# DRESDEN NUCLEAR POWER STATION UNIT 2

Special Report  
of  
Incident of June 5, 1970

Commonwealth Edison  
Company

## Supplementary Information

FIGURE 1. DRESDEN 2 DRYWELL VENTING DURING INCIDENT OF JUNE 28, 1970.

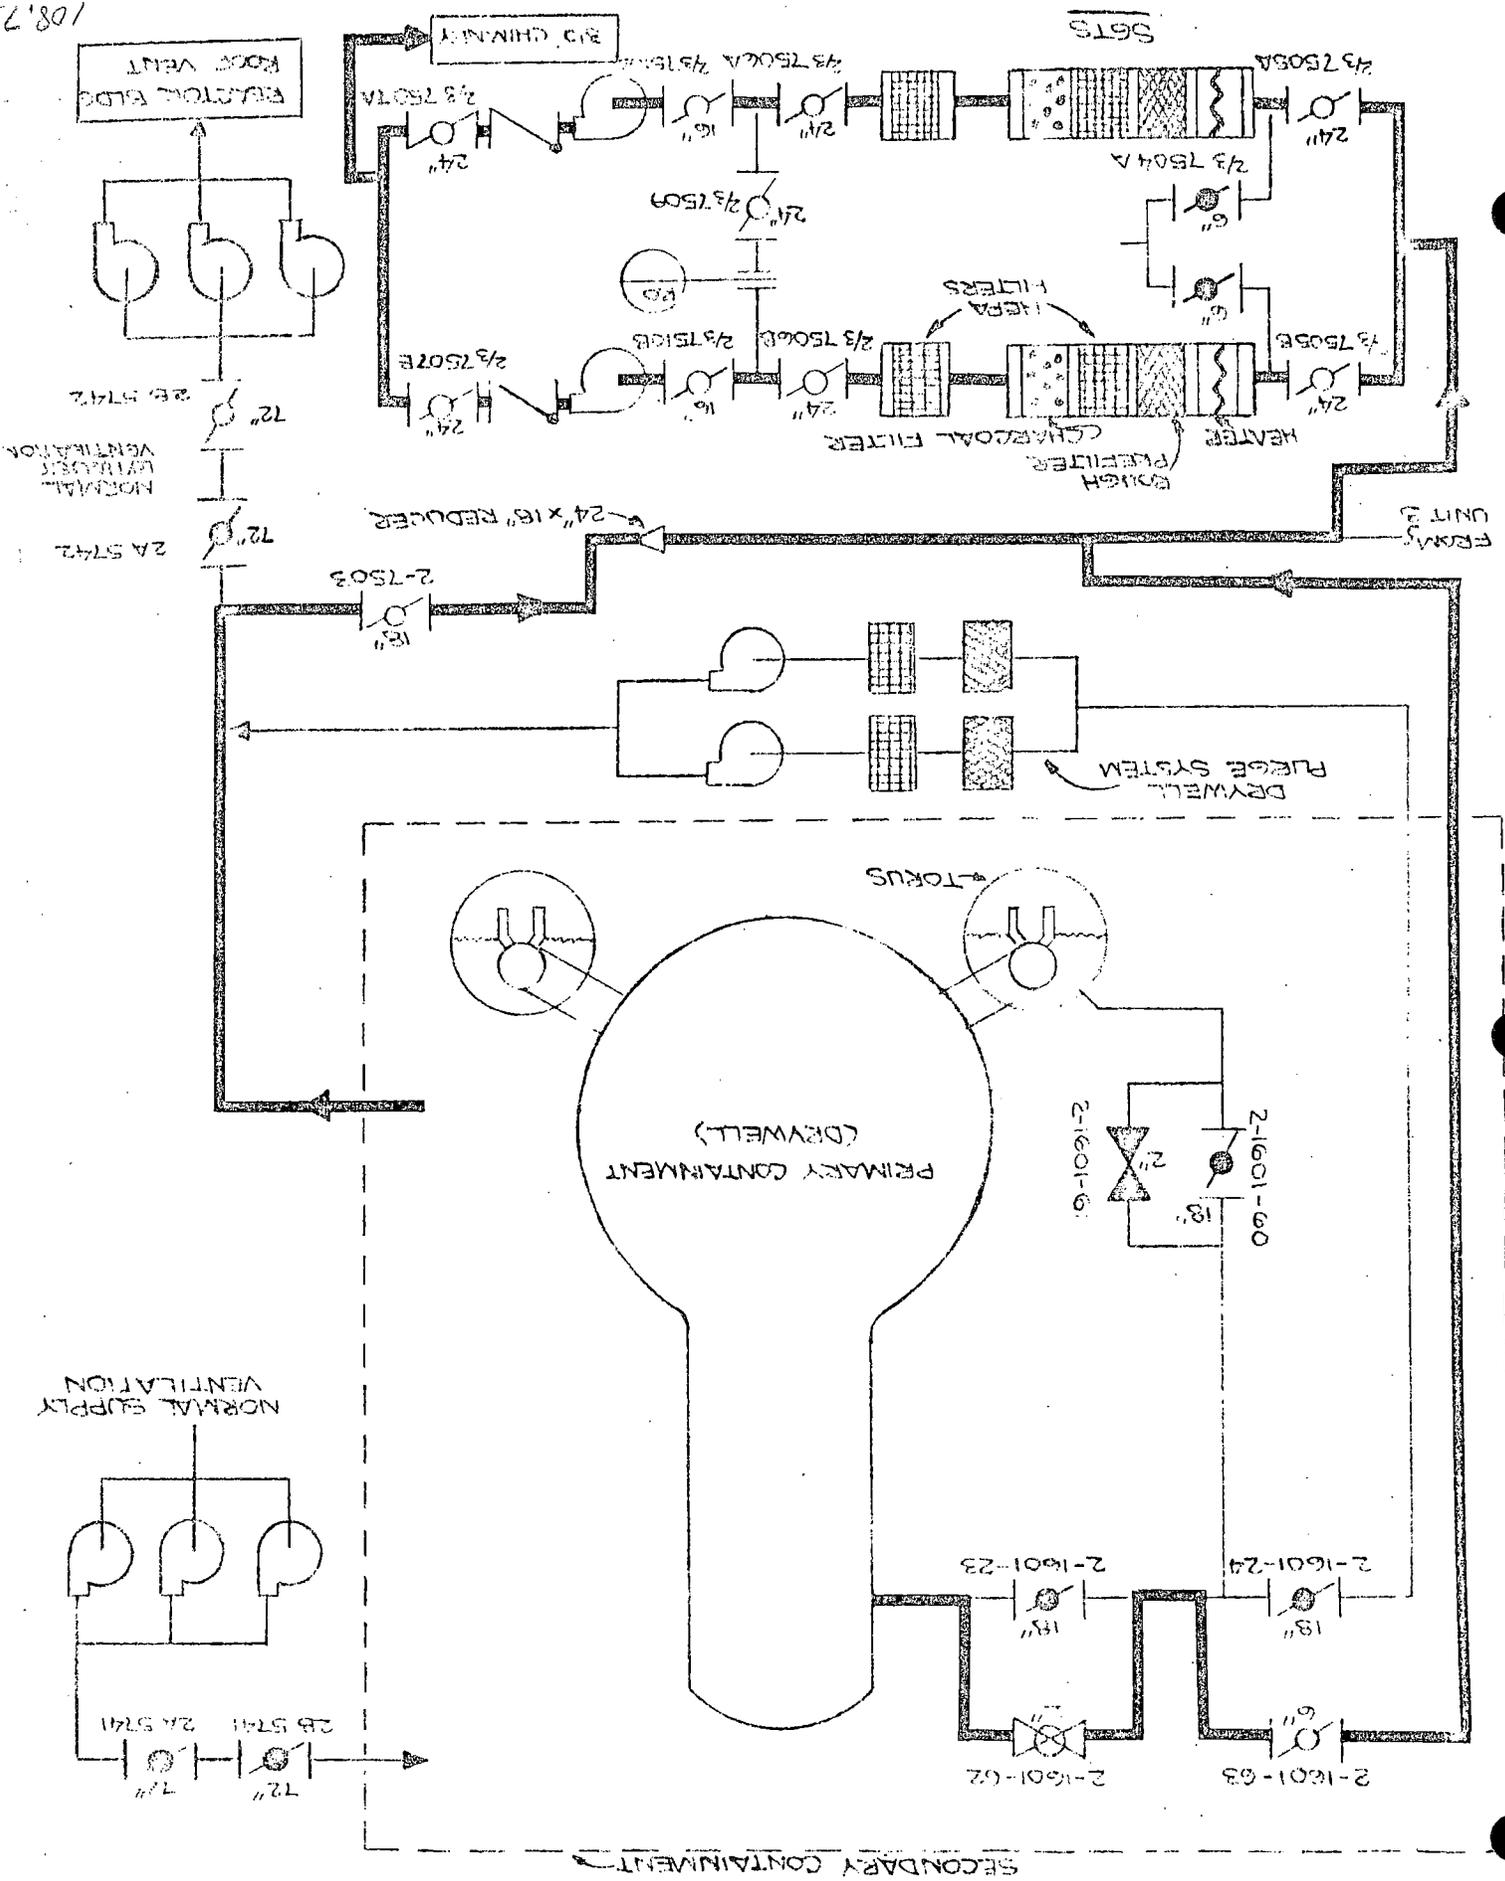
If it is postulated that the containment spray was turned on after the drywell wall had heated uniformly to 320°F, the drywell pressure and wall temperature would respond as shown in Figure 1. After 10 minutes the containment pressure has dropped to about 1 psig and the wall temperature to 300°F. Again this combination of buckling load would be less than the design case. In fact, even if the temperature was still 320°F and the pressure as low as 0.2 psig, the buckling load would be no worse than the design case (281°F @ 0 psig). Finally as indicated in the incident report, at 320°F and 0 psig the safety factor compared to allowable loading is 2.0.

FIGURE 6-1

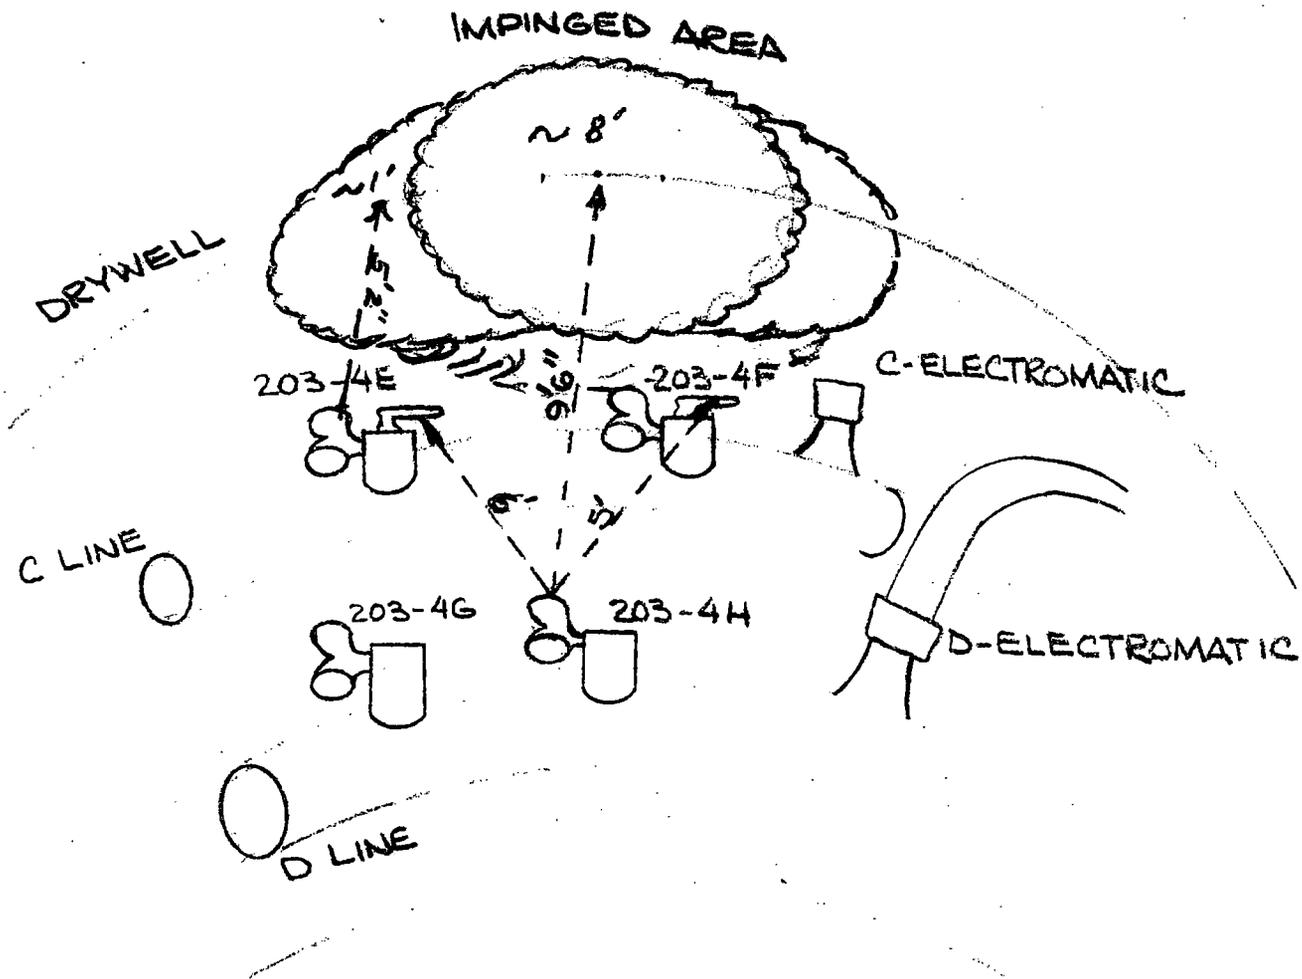
6. During the incident the steam discharged through the safety valves impinged on various components within the primary containment. Provide a sketch that shows which components were exposed to the steam jet and provide resulting pressure loadings to which such components were subjected. Relate these loadings to those included in design evaluations. Include in this evaluation the change (due to a heated valve and springs) in set points that could have resulted from the safety valves that were subjected to the steam jet.

A sketch that shows which components were exposed to the steam jet is shown in Figure 6-1.

The various components which were subject to the jet stream have been evaluated to determine the resulting pressure loading to which these components were subjected. The maximum stresses developed on any of the components occurred on the relief valve which was subject to a 4000 pound impingement load. This loading results in a maximum stress of 80% of code allowable.
